# National Committee on Uniform Traffic Control Devices

## NCUTCD Proposal for Changes to the Manual on Uniform Traffic Control Devices

**TECHNICAL COMMITTEE:** Regulatory and Warning Signs Committee  
**ITEM NUMBER:** 17B-RW-01  
**TOPIC:** Horizontal Alignment Signing  
**ORIGIN OF REQUEST:** NCHRP 03-106, Traffic Control Device Guidelines for Curves.  
Joint Task Force: Tom Heydel (chair), Bruce Ibarguen, Dan Waddle, Paul Carlson, Jim Pline, Bob Seyfried, Zoubir Ouadah (Markings Technical Committee), Dan Paddick.  
**AFFECTED SECTIONS OF MUTCD:** 2C.06, 2C.07, 2C.09, 2C.10, 2C.11, 2C.12, 2C.13, 2C.14, 2C.15.

**Figure 2C-2 Example of Warning Signs for a Turn**

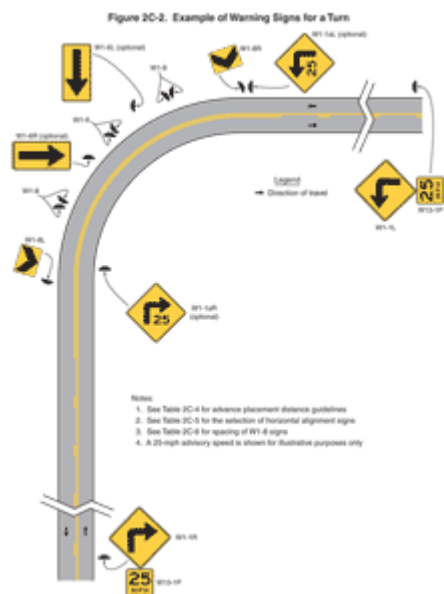
249 02.01 A turn sign (W1-1) should be used instead of a Curve sign in advance of curves when the  
250 advisory speed is 1/2 or less of the posted speed or a speed differential of 25 MPH or more exists.  
251 (approved by Council January 20, 2011, RW # 8, attachment #9)

256 03 02 Where there are two changes in roadway alignment in opposite directions that are  
257 separated by a tangent distance of less than 600 feet, the Reverse Turn (W1-3) sign should be  
258 used instead of multiple Turn (W1-1) signs ~~and~~ or the Reverse Curve (W1-4) sign should be used  
259 instead of multiple Curve (W1-2) signs.

261 02a Figure 2C-2 provides an example of warning signs used for a turn.
